Dear Mostafa, dear authors,

I am sorry to say, there is still one major issue which must be modified or clearly mentioned as a strong limitation in the approach, as the problem modeled is different, and this must be said. In short, the 2D approximation for a 3D helicoidal cable is simply wrong, or not justified enough. The issue is in the appendix A, where all the modeling development is performed. At line 507, you mention that “because the plane wave incident upon layer 1 is assumed to lie in the X-Z plane”, then “the problem becomes 2D”. This is simply wrong. I try to show it in the figure below.

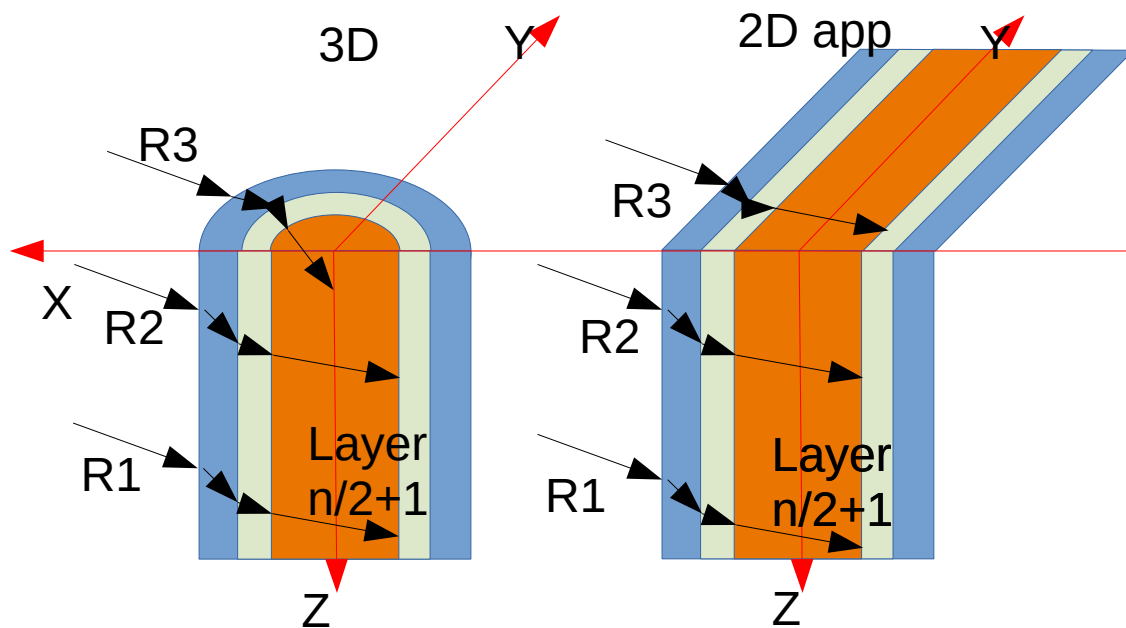
On the left, the 3D real situation is represented, on the right the 2D approximation. In the 3D case, even if the incident plane wave is in the plane XZ, there will be rays (example R3) which will reflect in the layers with a different path as the one in the XZ plane, as they hit the layer one with a different incident angle, and therefore will modify amplitudes of the signal caught by both fibres, linear or helicoidal. In 2D, this is much more simple to evaluate indeed, as R3 will not interact with the plan XZ at the location of the cable, and will behave as R1 and R2, and not interact with R1 and R2”, contrary to the 3D situation.

Therefore, the approximation of the 3D into 2D is completely wrong and you cannot claim that the equations you derive are an approximation for the 3D case. As long as I do not see a true comparison between the real situation modeled in 3D and the 2D approximation, I would not agree that the discrepancy is small enough that your results represent an approximation of the 3D.
